# SUPPLEMENTAL RESPONSES TO CEC STAFF DATA REQUEST SET 1 (11,13,14, 19- 23, 31, 32, AND 34-36)

STACK SVY03A Campus (23-SPPE-01)

SUBMITTED TO: CALIFORNIA ENERGY COMMISSION

SUBMITTED BY: **STACK Infrastructure**

1 MECHANICAL ROOF HVAC OVERALL PLAN  
MH-203.00 1/8" = 1'-0"

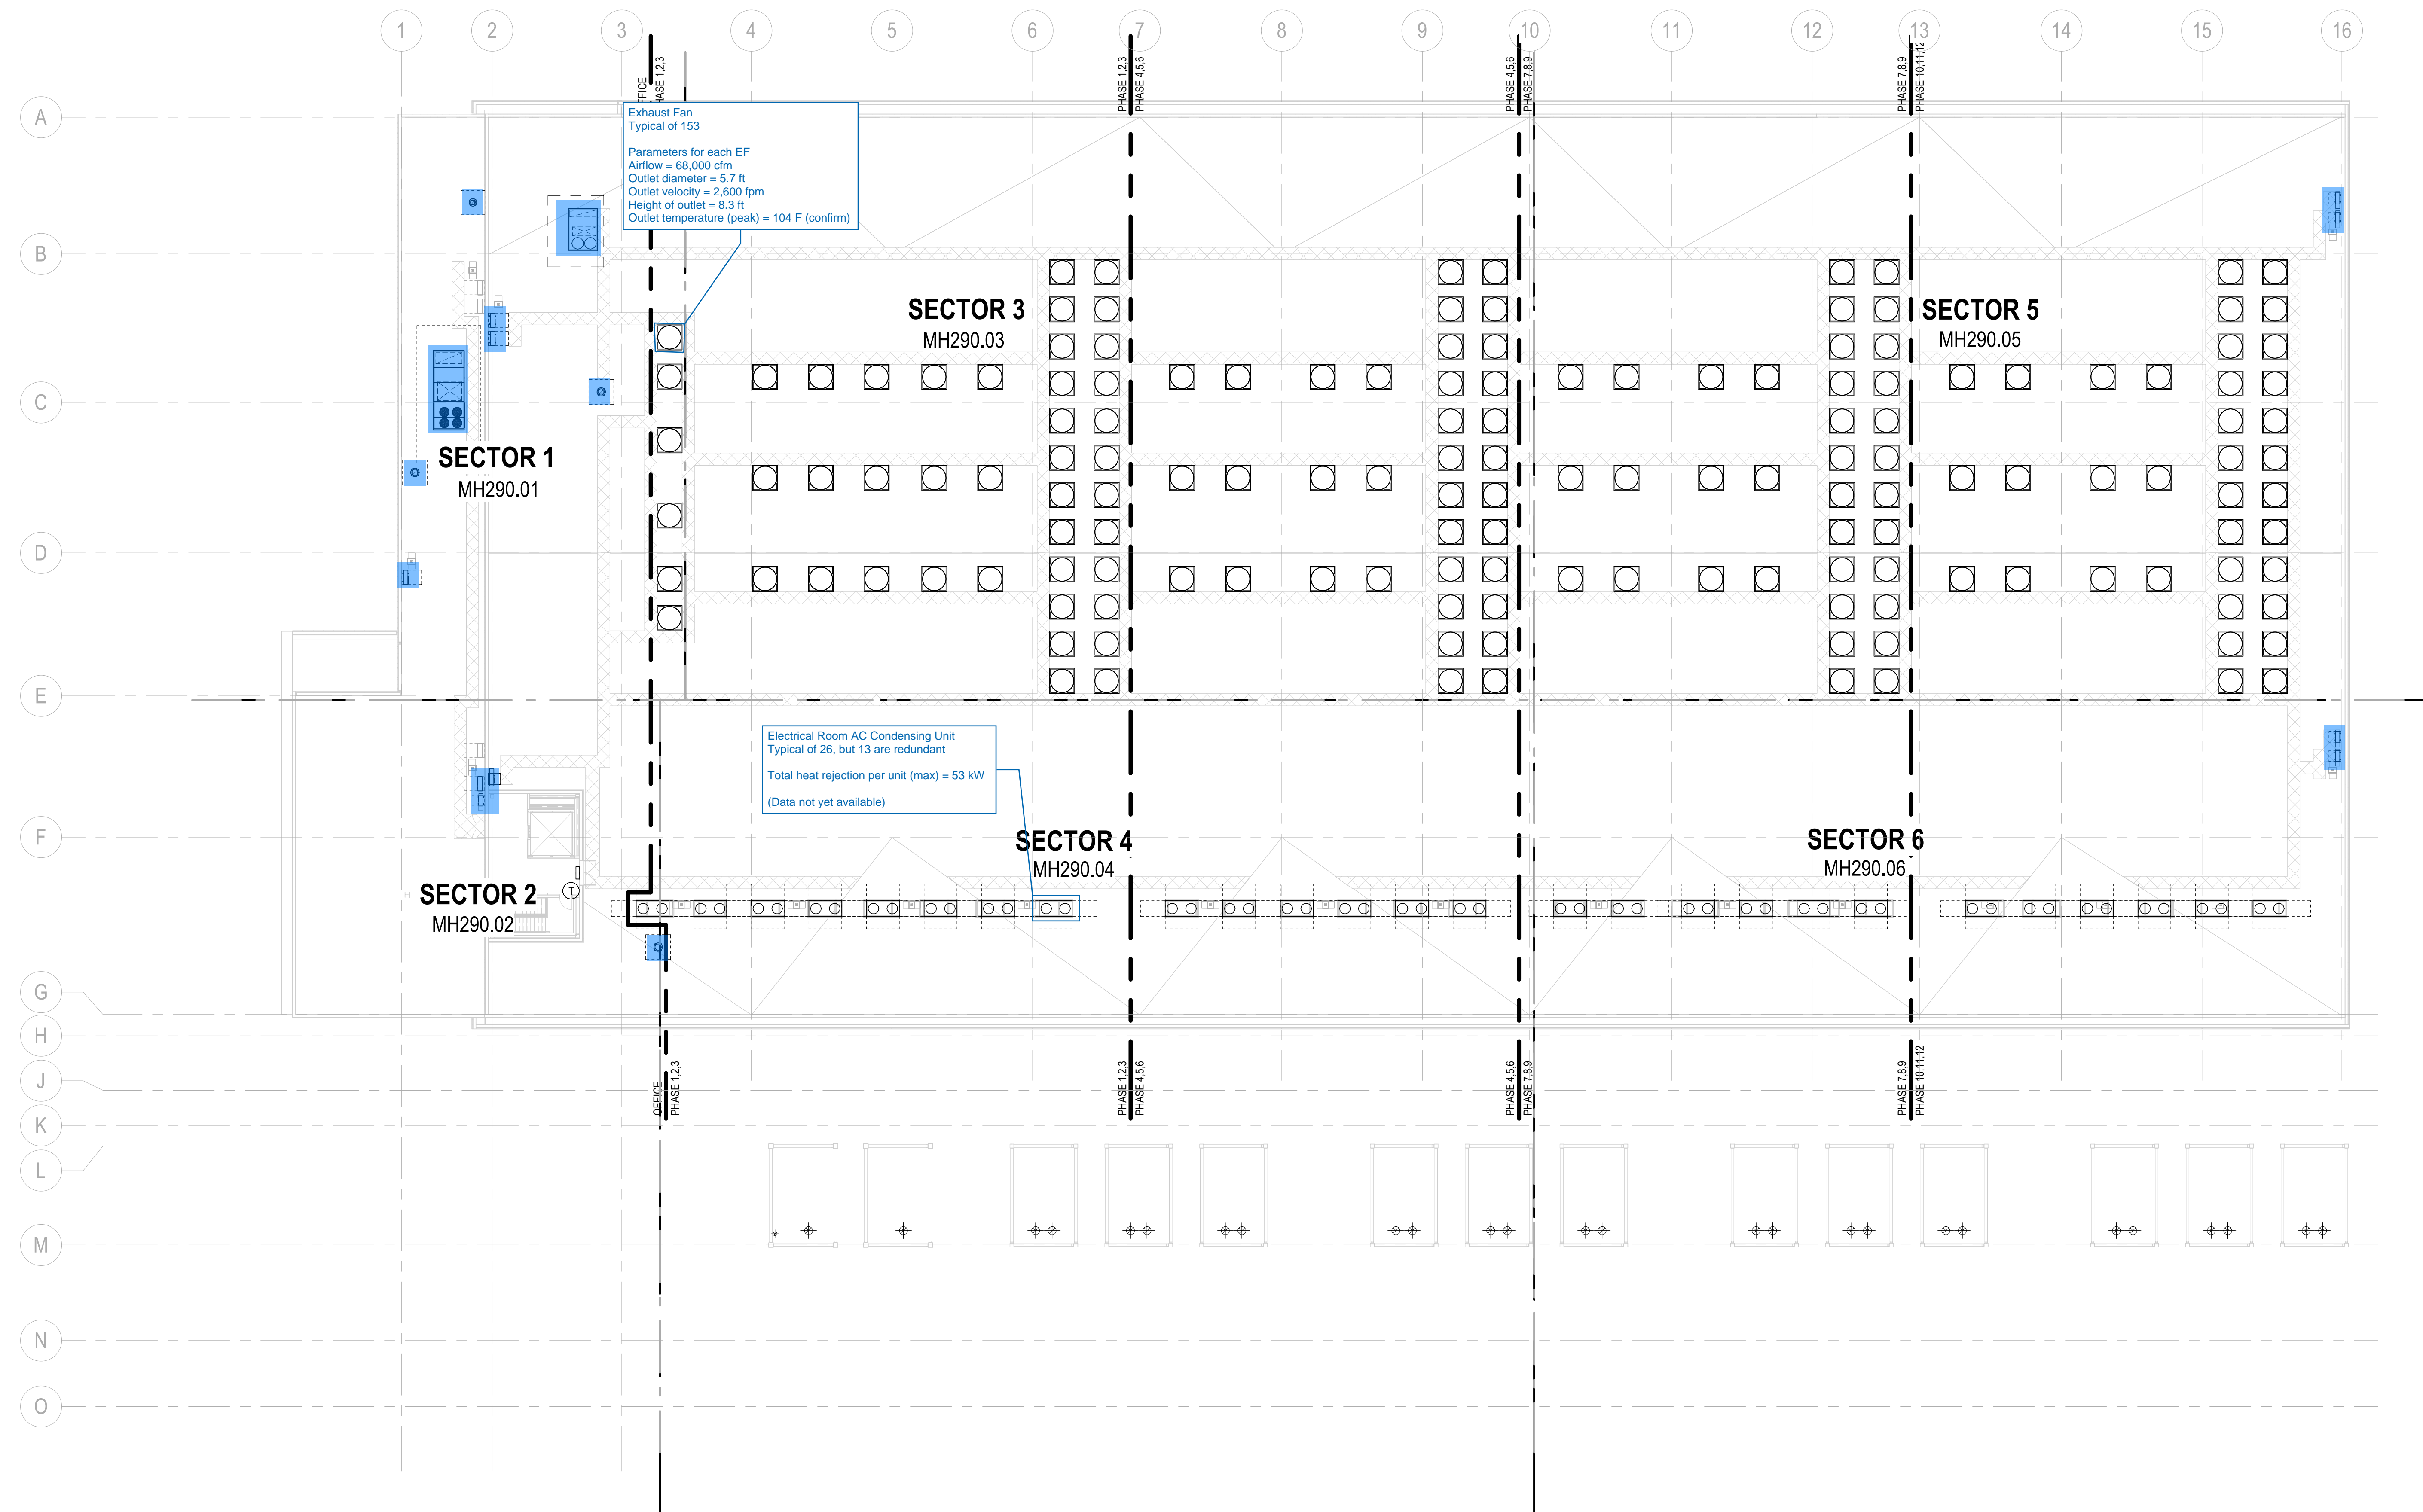
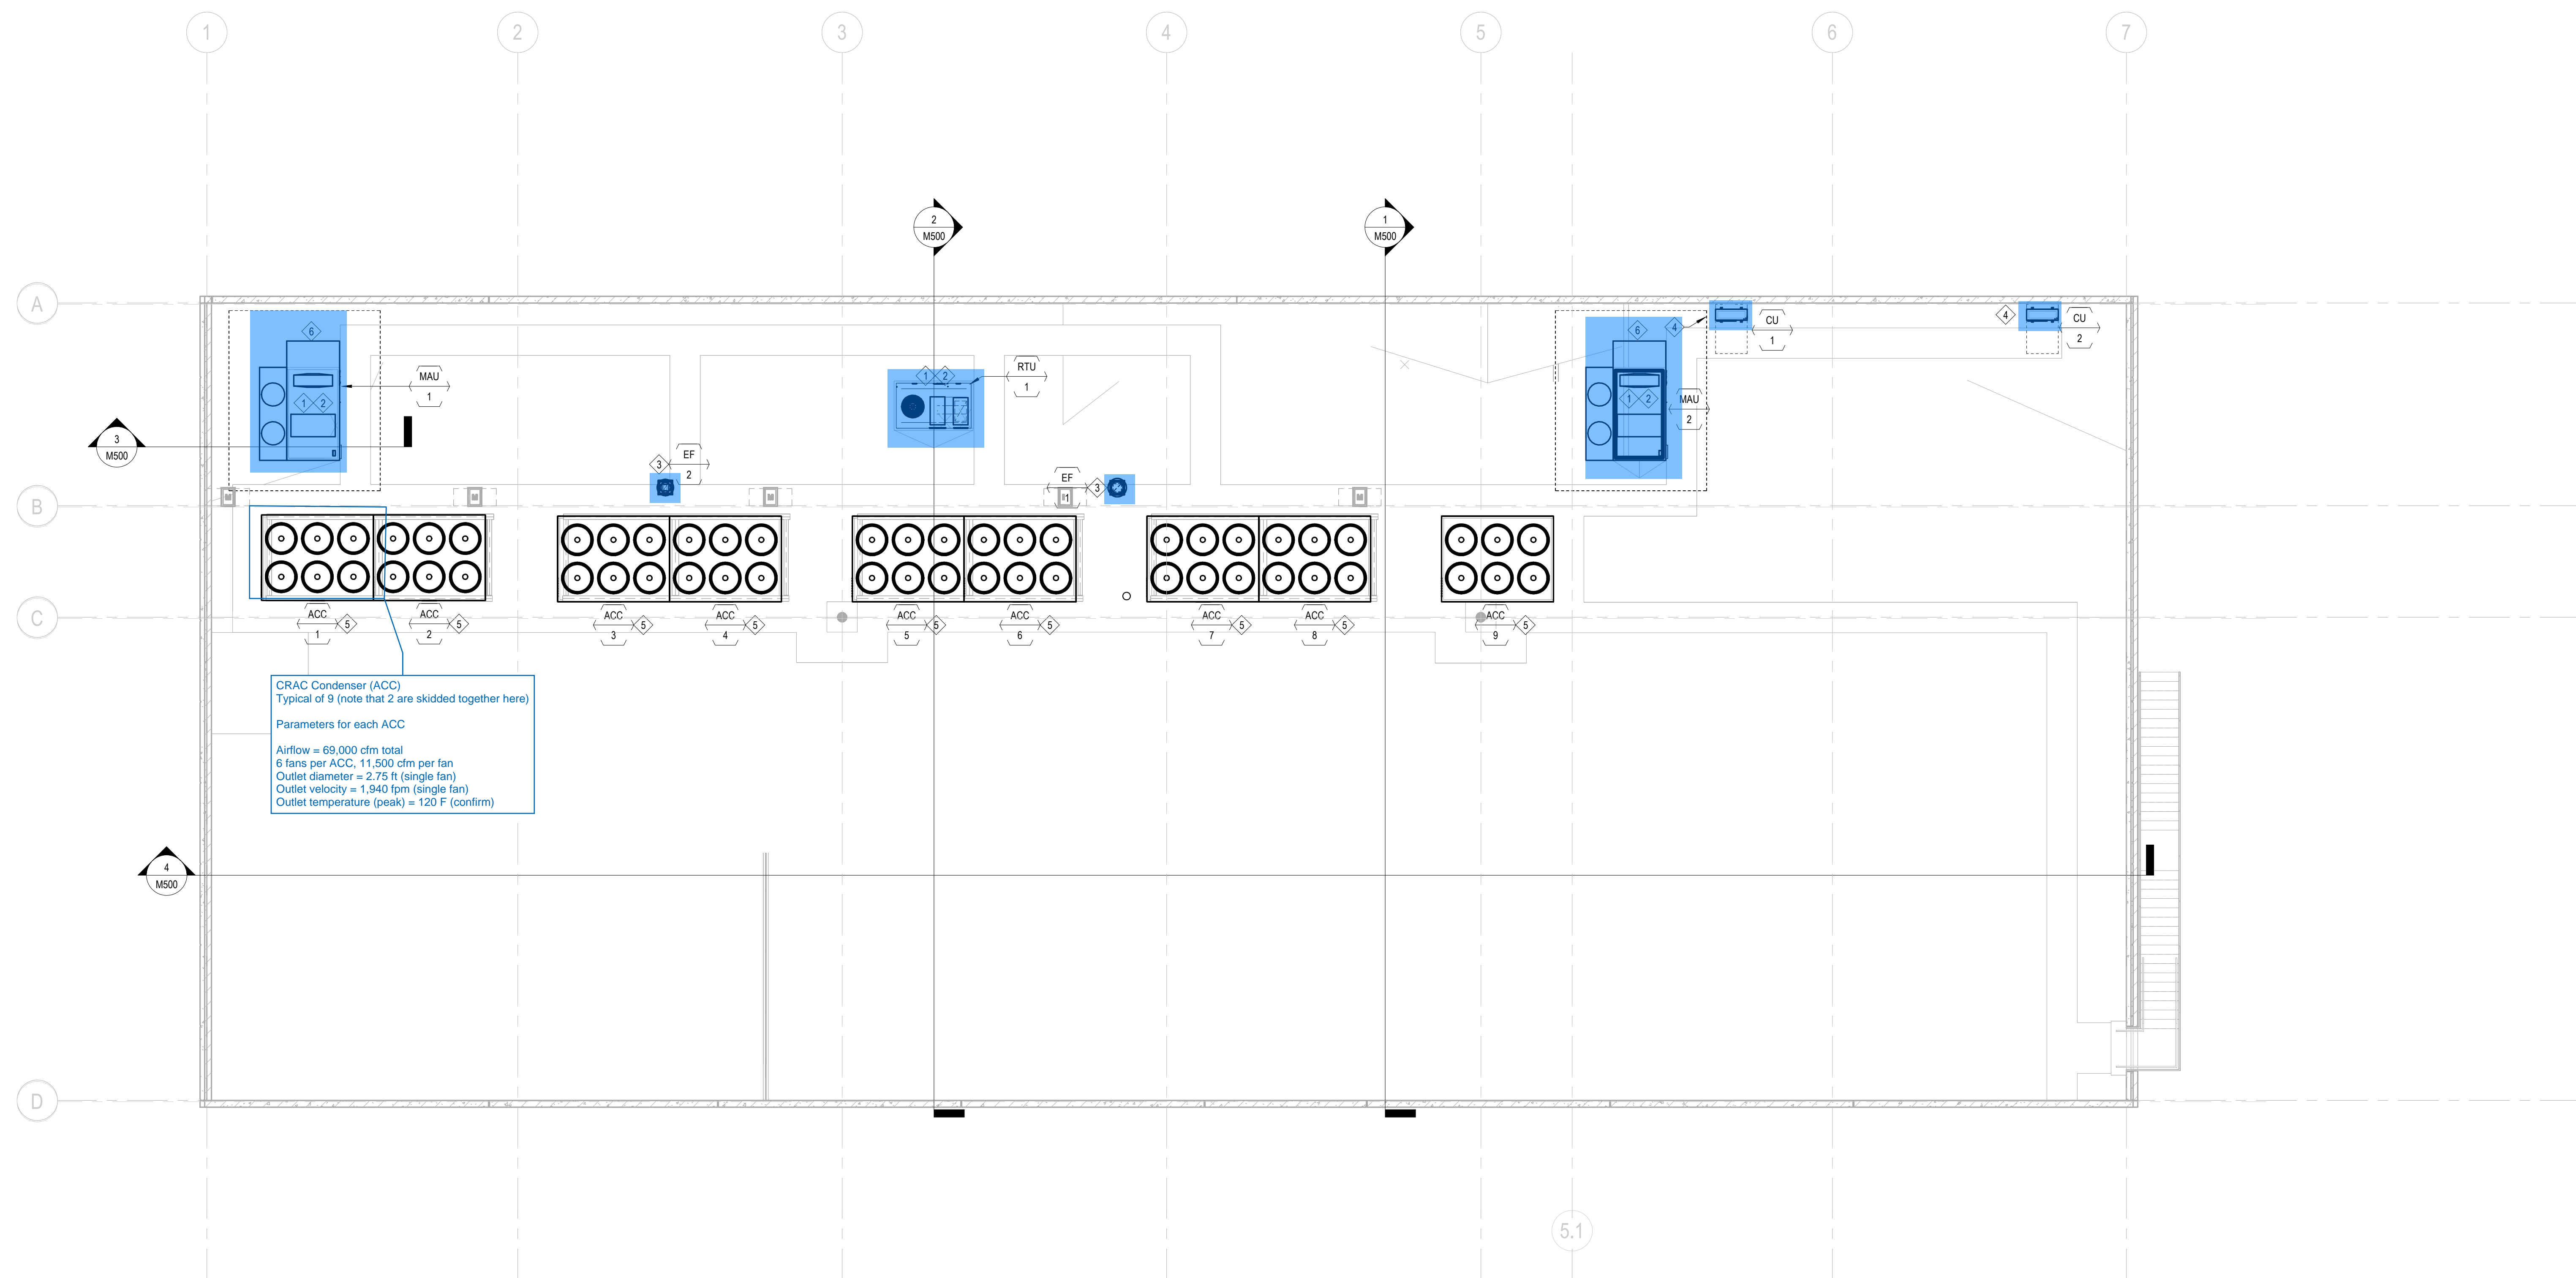
34. Please provide a labeled schematic, showing all mechanical equipment on the roof of the SVY03ADC1 and SVY03ADC2 buildings.

Please see Attachment TRANS DR-34.
